Working Paper No. HDH-11-05e  
(11th HDH meeting, 10 to 12 October 2012)

# Results of Examination and Issues to Address Regarding WHDHC

JAPAN AUTOMOBILE STANDARDS INTERNATIONALIZATION CENTER

▼ Confirmation of WHDHC in SILS

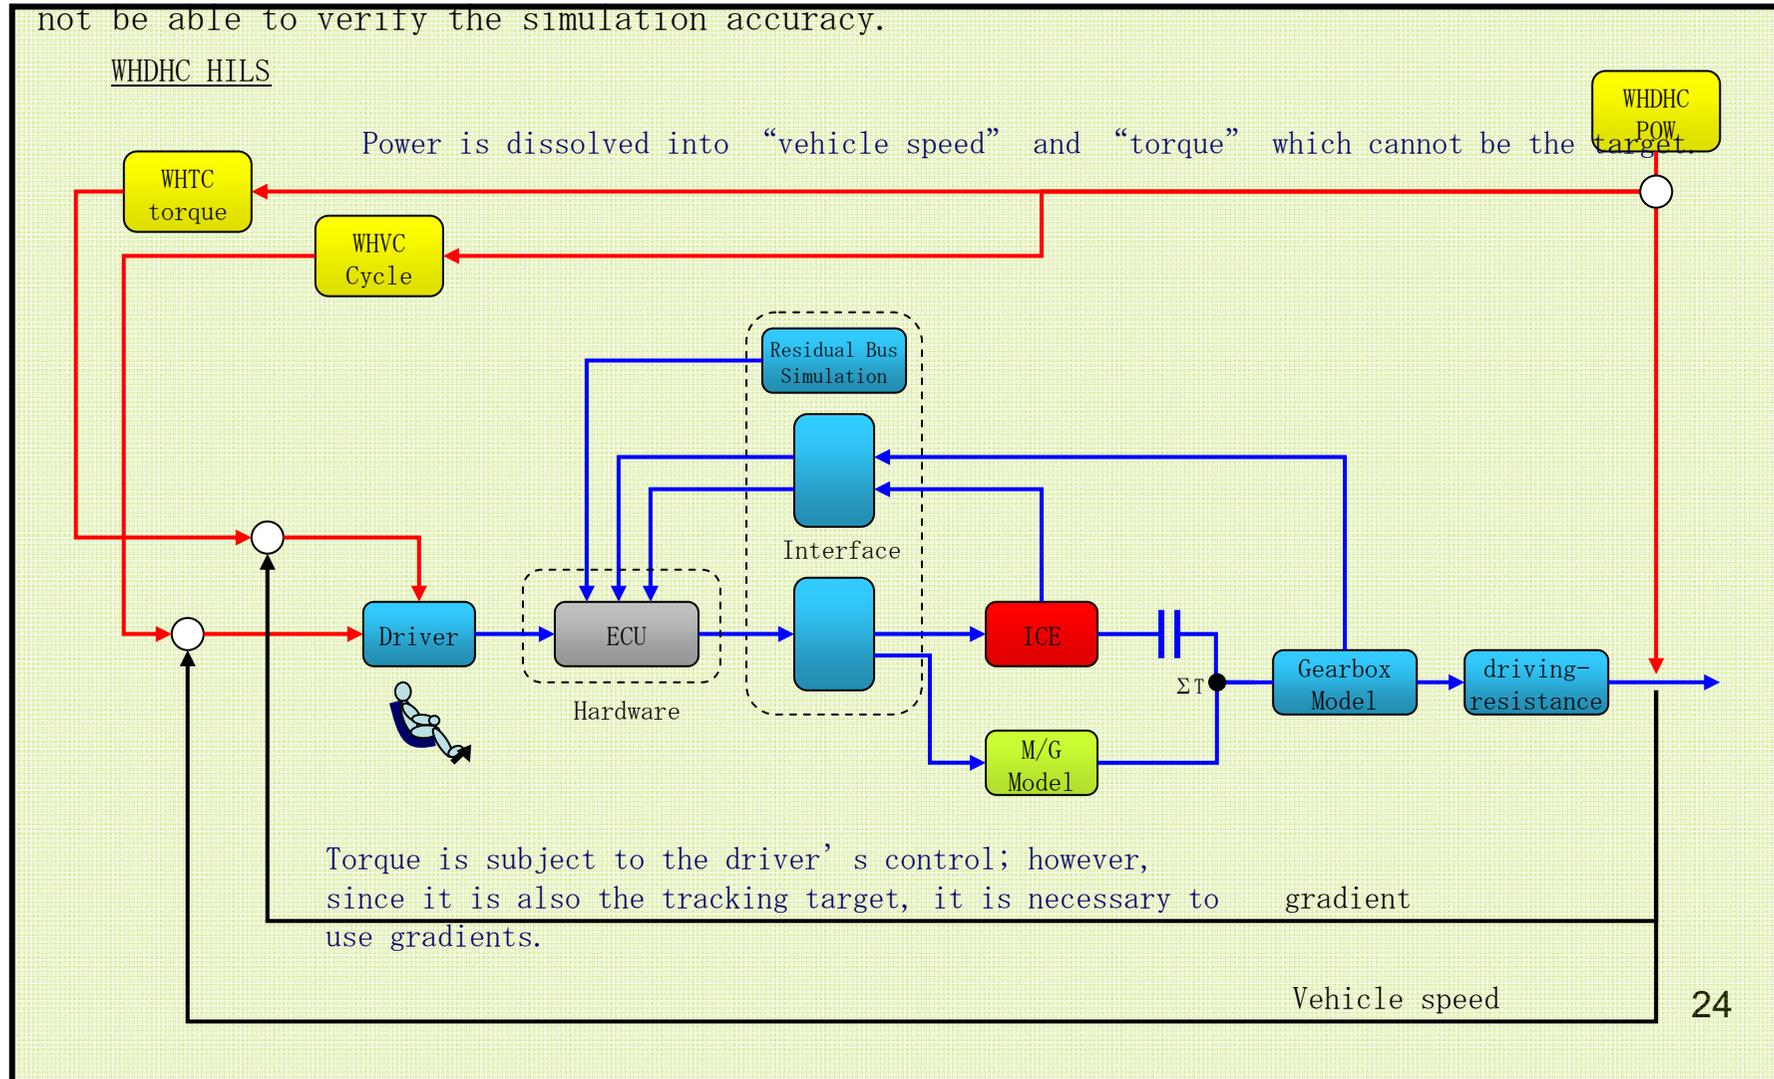
If fixed gradients were used, predictive control would be easy since the accelerator/brake commands required for the vehicle speed/acceleration would be determined consistently. However, in the case where gradients change every second, even if the vehicle speed/acceleration remains unchanged, the accelerator/brake opening changes every time, and prediction will be impossible, leading to lowering of the tracking performance.

In SILS, although simulation was possible to some extent, since the acceleration did not match its target value, the correlation with WHDHC in torque and power was lowered. In HTLS,

simulation was not performable.
